Docket Number:	11-AFC-01C
Project Title:	Pio Pico Energy Center - Compliance
TN #:	206406
Document Title:	Heat Input PTA - Response to Staff Request
Description:	N/A
Filer:	Dale Rundquist
Organization:	California Energy Commission
Submitter Role:	Commission Staff
Submission Date:	10/20/2015 12:56:46 PM
Docketed Date:	10/20/2015

DATA REQUEST

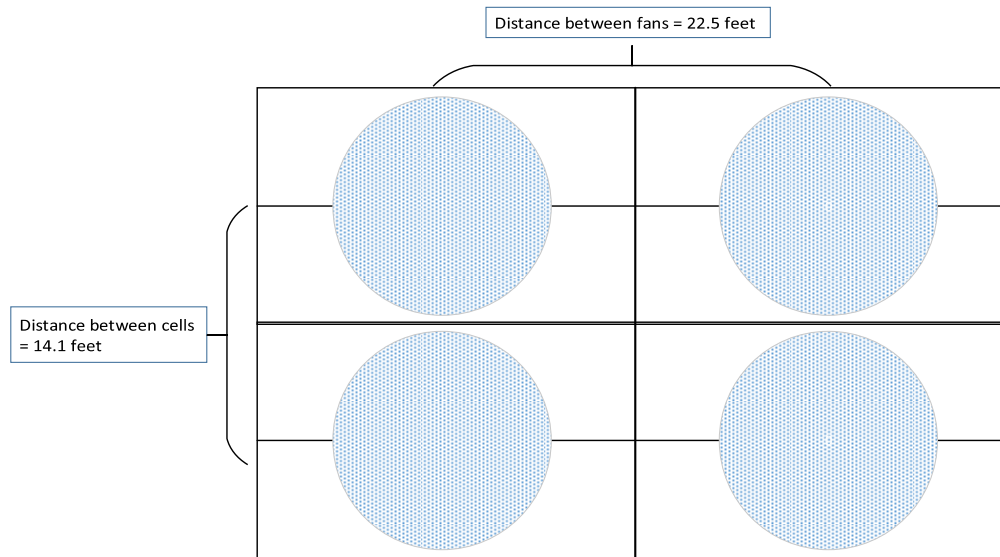
Response: The requested thermal plume analysis was performed using the Spillane methodology typically used by the CEC staff for analyzing thermal plume impacts; the results are attached. The highest individual thermal plume velocity is only about 2.40 meters per second (m/s) and the highest merged plume velocity is only about 4.04 m/s. As the staff is aware, the spreadsheet-based model that implements the Spillane methodology utilizes a single, fixed distance between the release points to evaluate the velocity profile of a source with multiple release points. As shown in Appendix A to the July 31, 2015 Petition to Amend related to the Wastewater Storage Tanks (TN 205609), the air cooled heat exchanger (ACHE) consists of 8 cells with two fans per cell. For this ACHE configuration, however, the distance between each cell is different than the distance between the fans. A two-cell section of the

ACHE is shown below to illustrate the distinction. As a result, it would not be accurate to model the ACHE based on all 16 fans.

The model results presented here use the distance between the cells, 14.1 feet, and the number of cells, 8, to calculate the velocity of the merged plumes.

Assuming that the exhaust velocity from each cell of the ACHE is constant for all ambient conditions, the highest individual thermal plume velocity is only about 2.40 meters per second (m/s) and the highest merged plume velocity is only about 4.04 m/s.
